Technical Service Bulletin: TSB240101	Released Date: 16-Jul-2024
New Lubricating Oil Pan and Lubricating Oil Pan Gasket to Reduce External Lubricating Oil Leaks

# New Lubricating Oil Pan and Lubricating Oil Pan Gasket to Reduce External Lubricating Oil Leaks

Figure 1, Lubricating Oil Pan Gasket, Part Number 5682084.

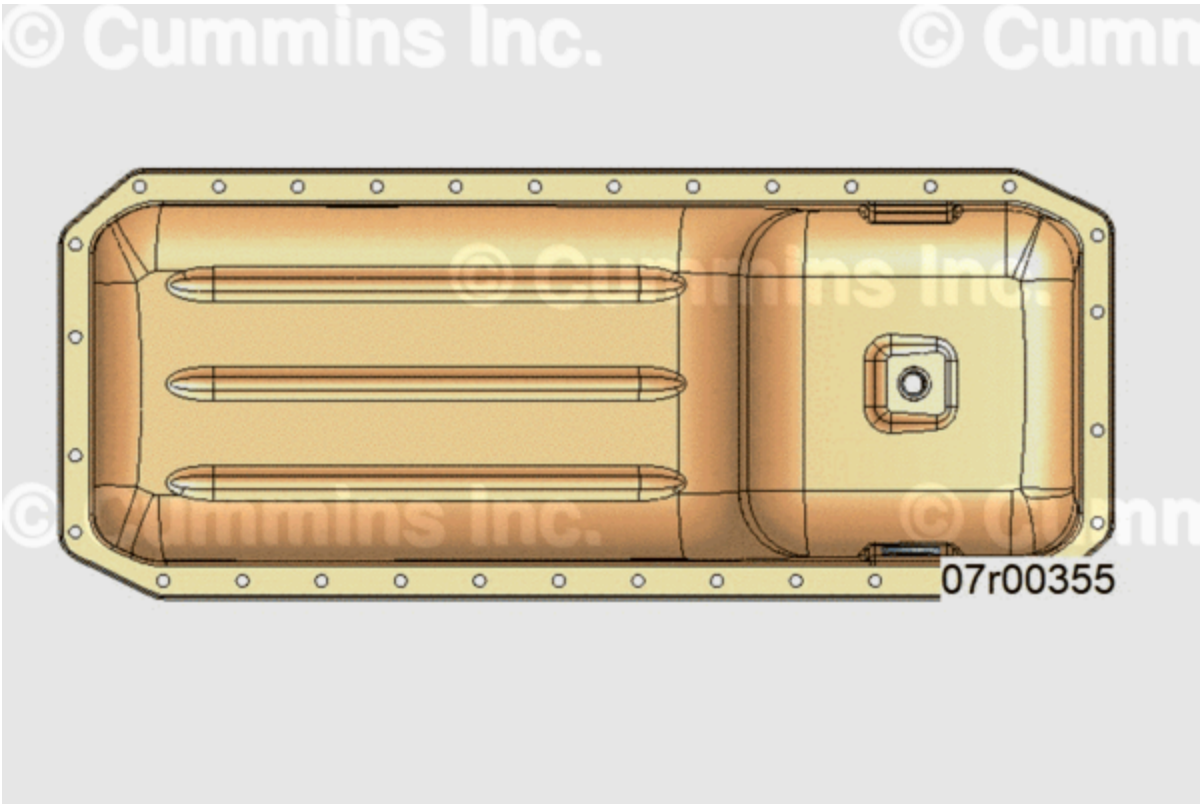
- A new lubricating oil pan and lubricating oil pan gasket are available to reduce the risk of external lubricating oil leaks.
- Installation procedures have been updated for the new parts.
  - Reference the Service Issue column Table 1.
  - See corresponding Service Manual. Reference Procedure 007-025 in Section 7.

- The new lubricating oil pan and lubricating oil pan gaskets better distribute sealing pressure across the lubricating oil pan gasket and reduce clamp load loss over time to reduce the risk of external lubricating oil leaks.
- All new products are built with the new lubricating oil pan and lubricating oil pan gasket part numbers.

New parts are **not** backwards compatible and are **not** able to be used with existing parts. Reference Table 2.
